LAS-03-0004

UNLESS OTHERWISE SPECIFIED: DIMENSIONS ARE IN MILLIMETERS SURFACE FINISH: TOLERANCES: LINEAR: ANGULAR:						FINISH:		DEBURR AND BREAK SHARP EDGES		DO NOT SCALE DRAWING		REVISION		B	
		NAME		SIGNATURE		DATE						TITLE: LAS ELEVATION AXIS PIVOT MOUNT			
DRAWN															
CHK'D															
APPV'D															
MFG															
Q.A								MATERIAL:		DWG NO.		LAS-03-0004		A3	
								WEIGHT:		SCALE:1:2		SHEET 1 OF 2

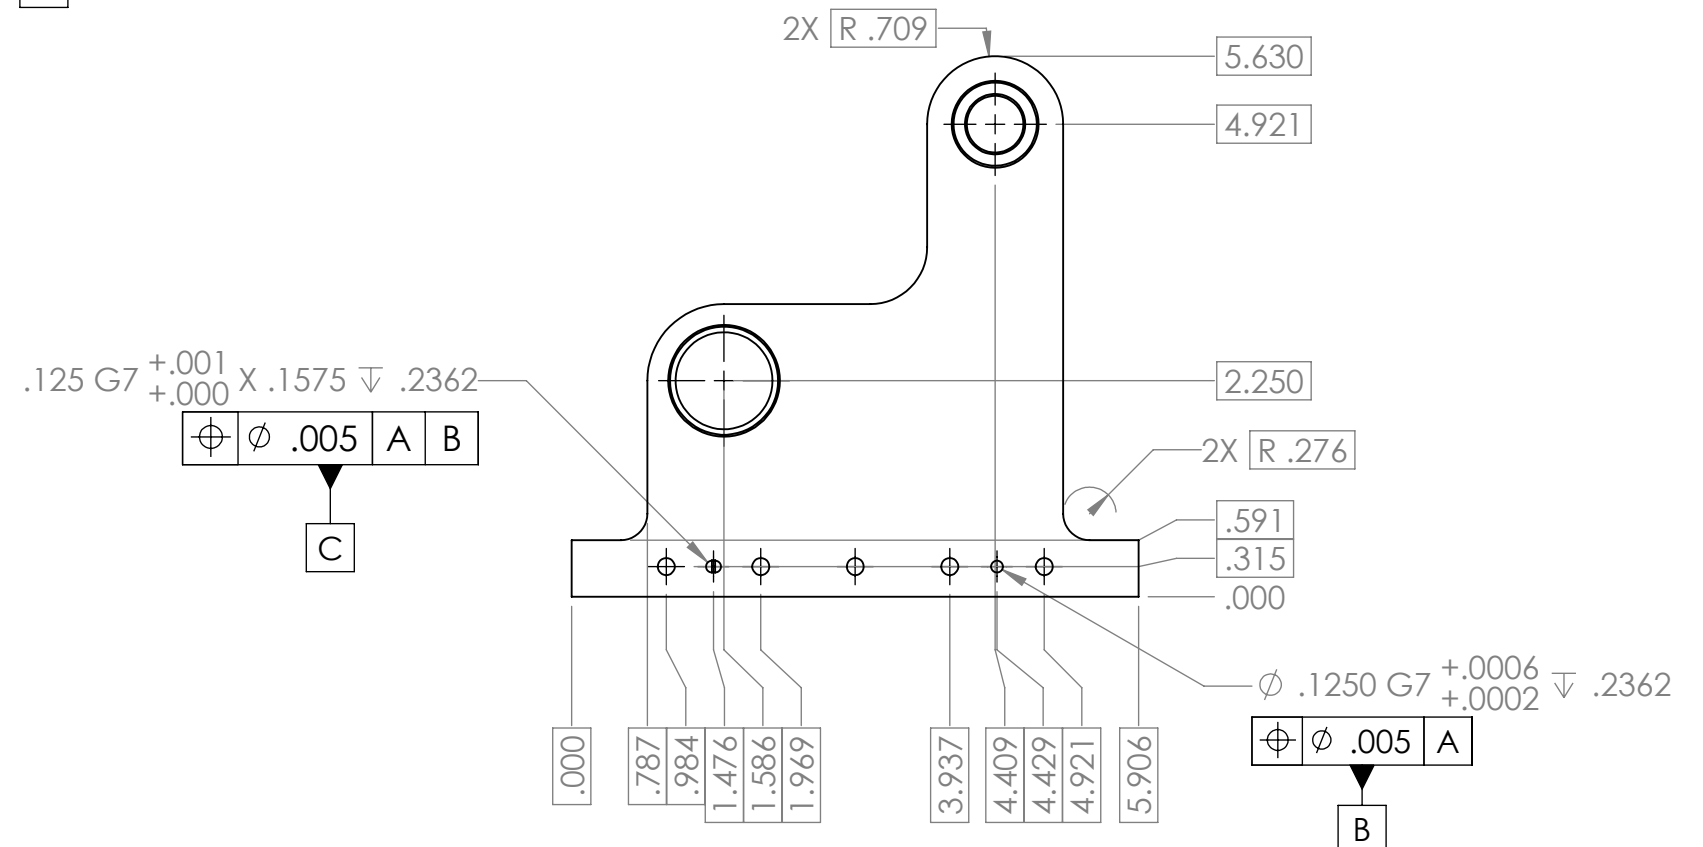
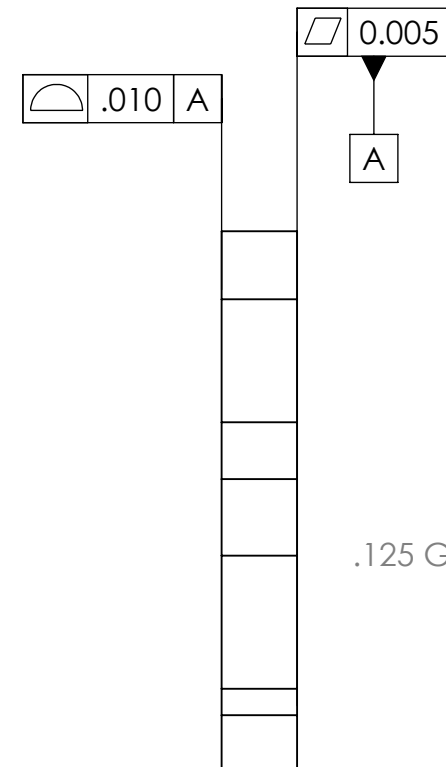
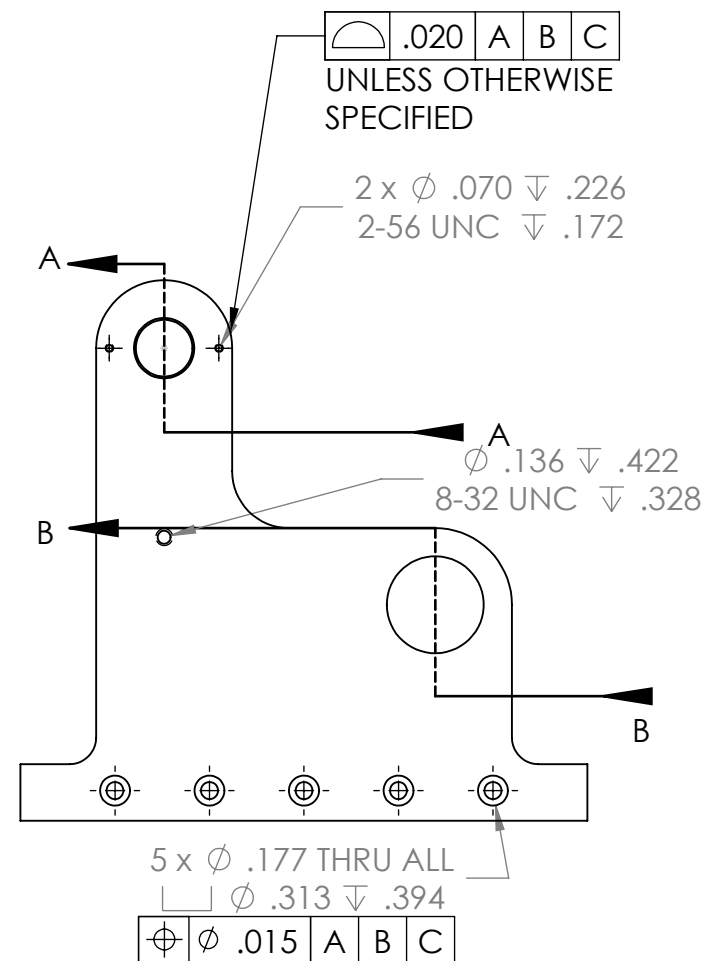
REVISIONS				
ZONE	REV.	DESCRIPTION	DATE	APPROVED
2-A5, 2-D6	A	REVISED DIMENSION. WAS .293±.005 TO INNER CHAMFER. NOW .313+.005/-000 TO OUTER FACE. REVISED DIMENSION. WAS .276 +.005/.005 NOW .276+.005/-000	10/28/2020	ADA
